<b>PROJECT:</b>	NECC DINING FACILITY AND RESIDENCE HALL	<b>PROJECT NO.</b>	L14089
<b>FROM:</b>	BVH ARCHITECTS	<b>DATE:</b>	9-24-2014
<b>TO:</b>	PROSPECTIVE BIDDERS	<b>ADDENDUM NO.</b>	2

**ADDENDUM NO. 2**

Northeast Community College Dining Facility and Residence Hall  
Norfolk, Nebraska  
BVH Project No. L14089  
OA Project No. 014-1905

C-2  
 BID PACKAGE #1B

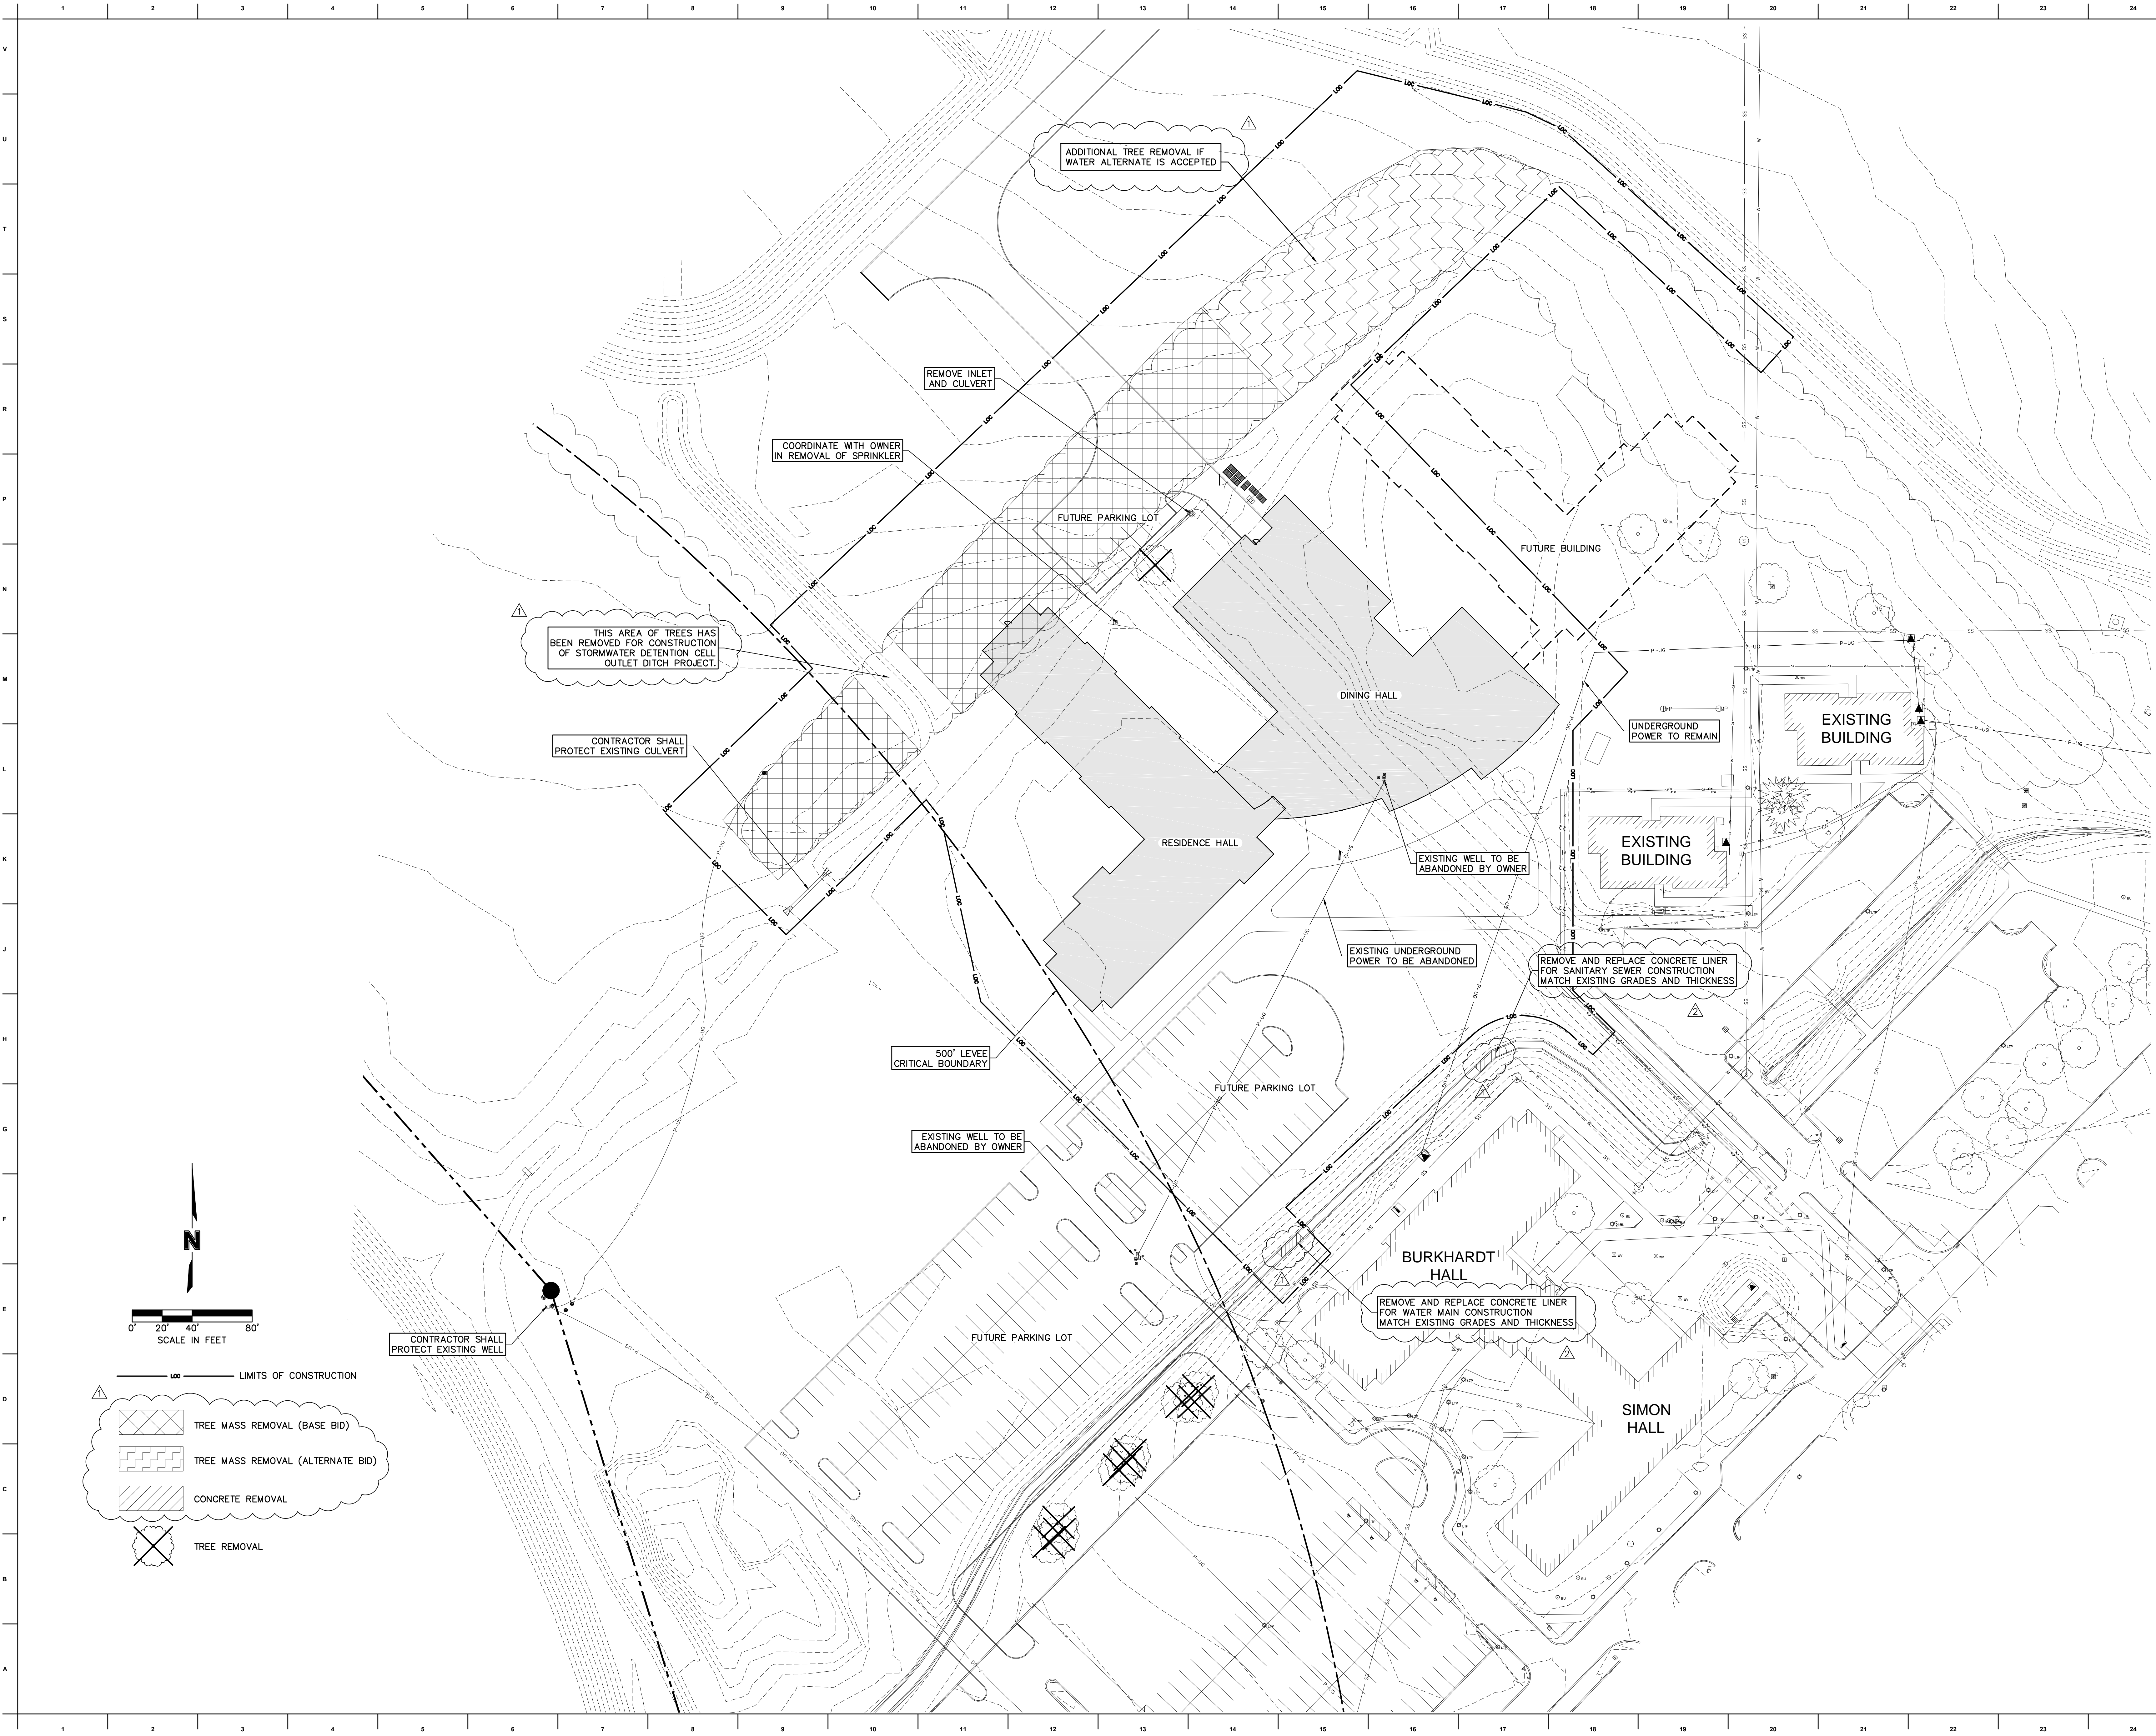
1. Refer to the Drawings, Replace Sheet C-2 Demolition Plan in its entirety

- a. Replacement of concrete ditch liner was added in two locations where utility connections will be made.

C-3.1  
 BID PACKAGE #1B

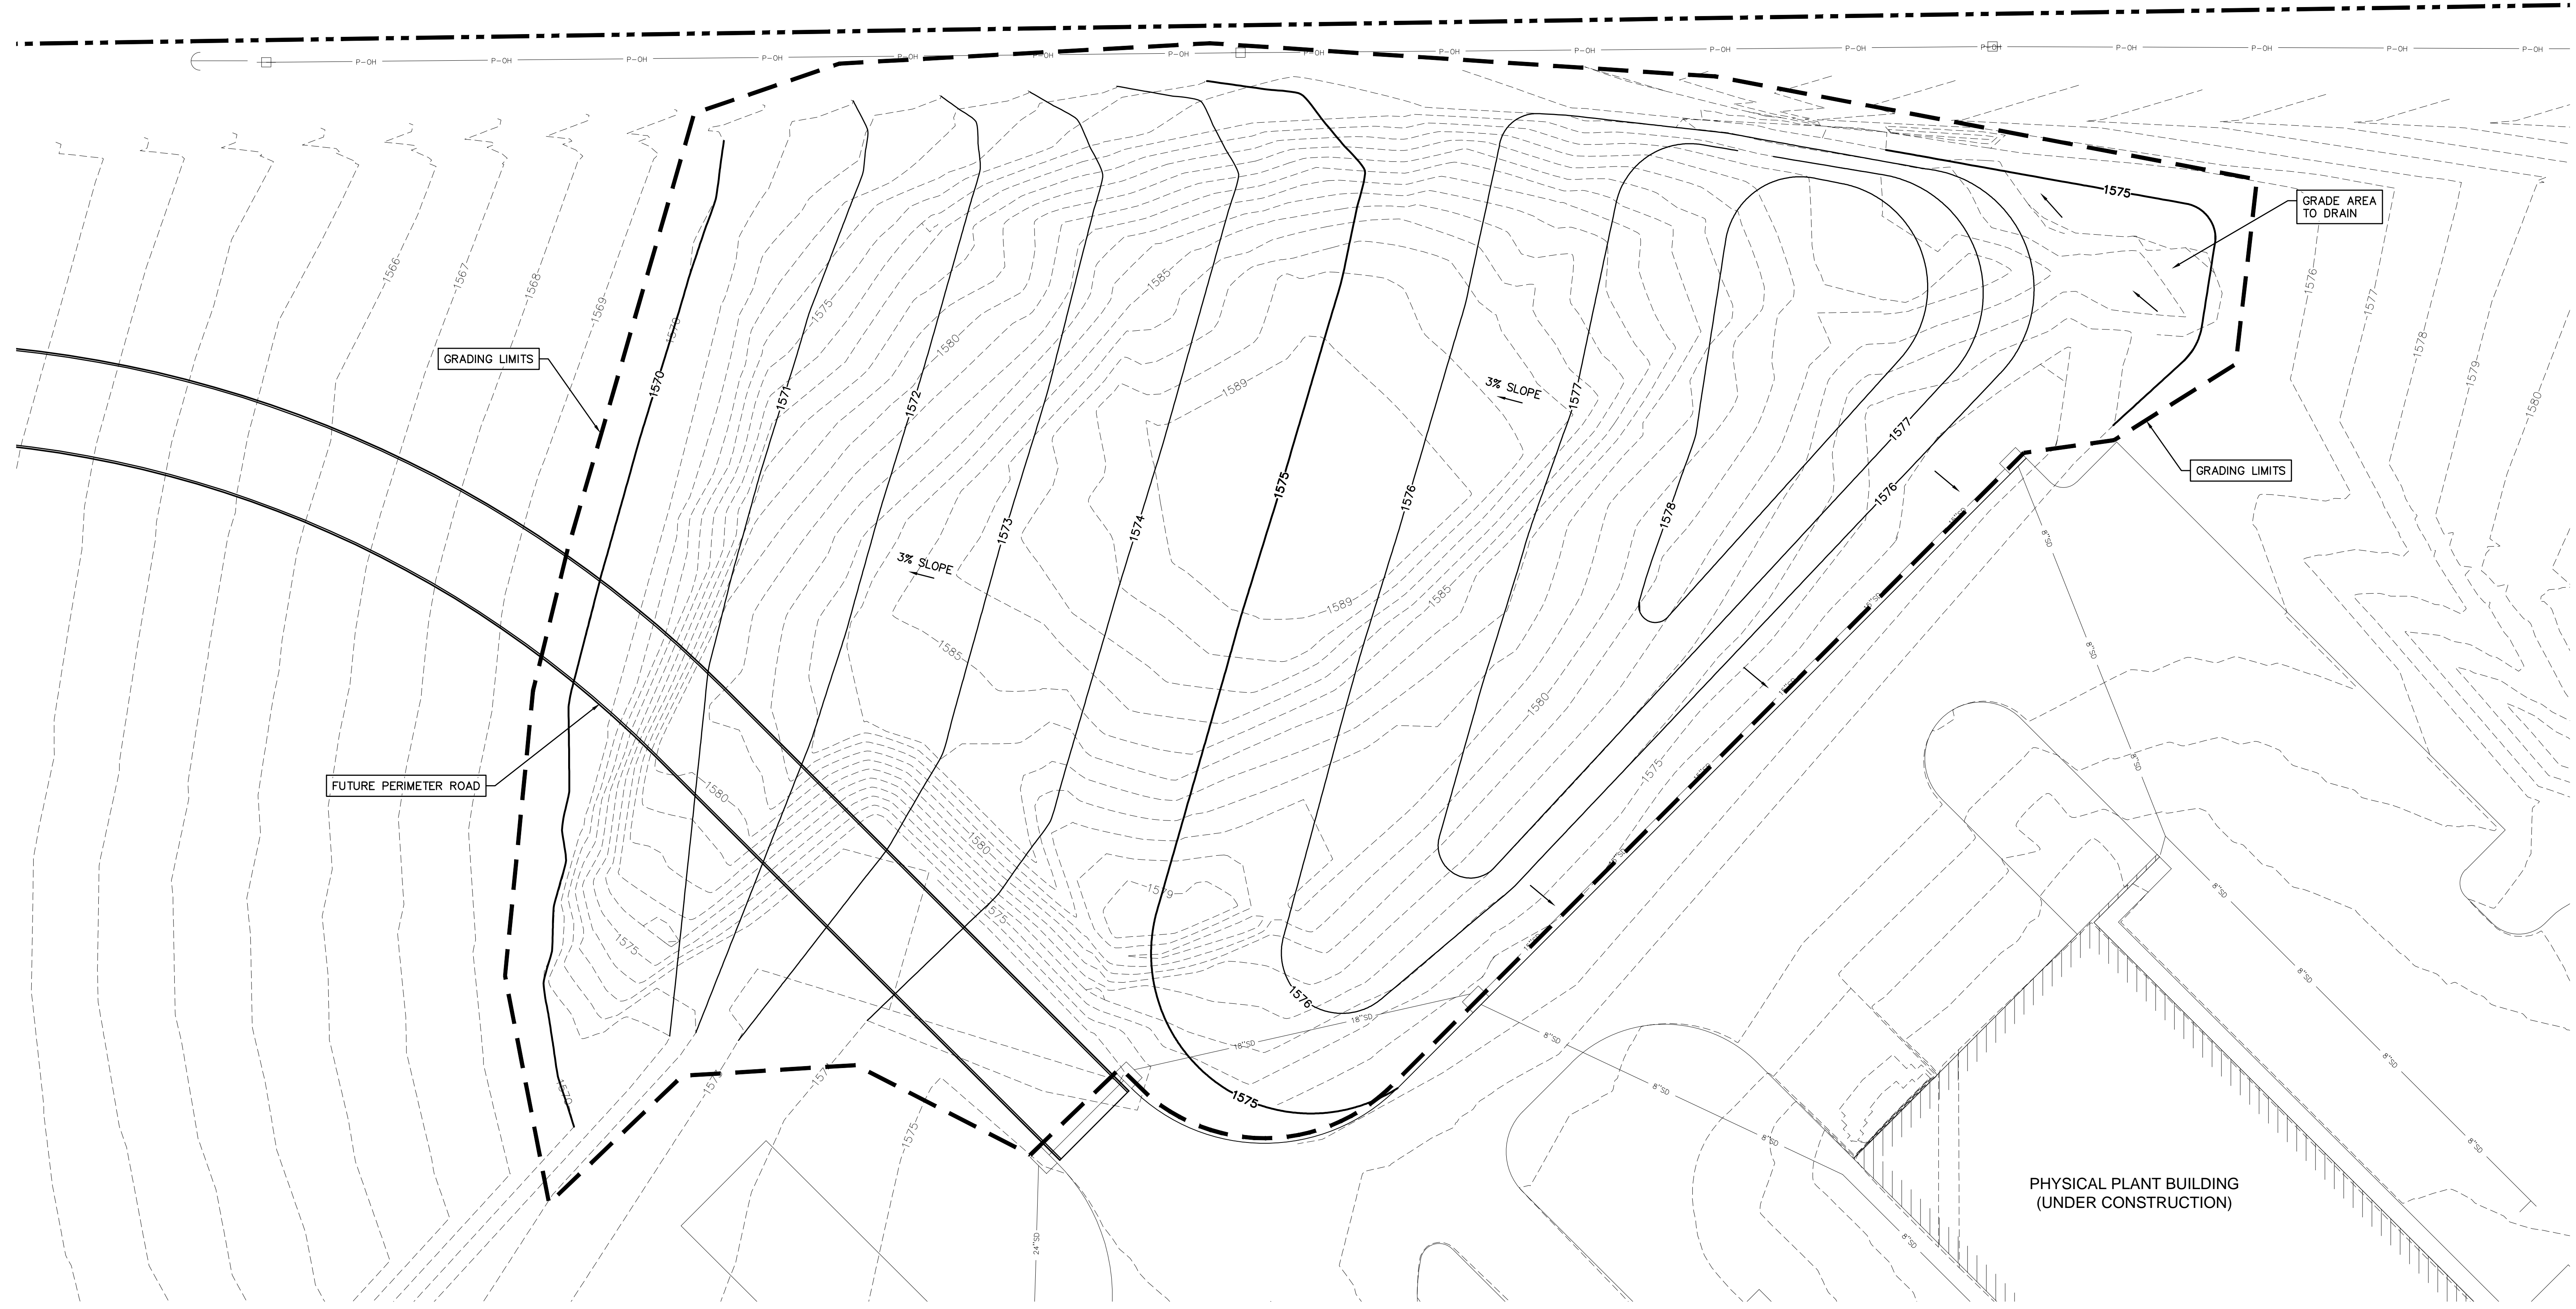
5. Cut material shall be used from Stockpile Area 'A' first before obtaining cut material from Stockpile Area 'B'. Final grading for Stockpile Area 'A' is shown on Sheet C-3.1.

3. Refer to the Drawings, Add Sheet C-3.1 Stockpile Grading Plan

- a. Existing contours and final grading in the stockpile areas are shown on this sheet.
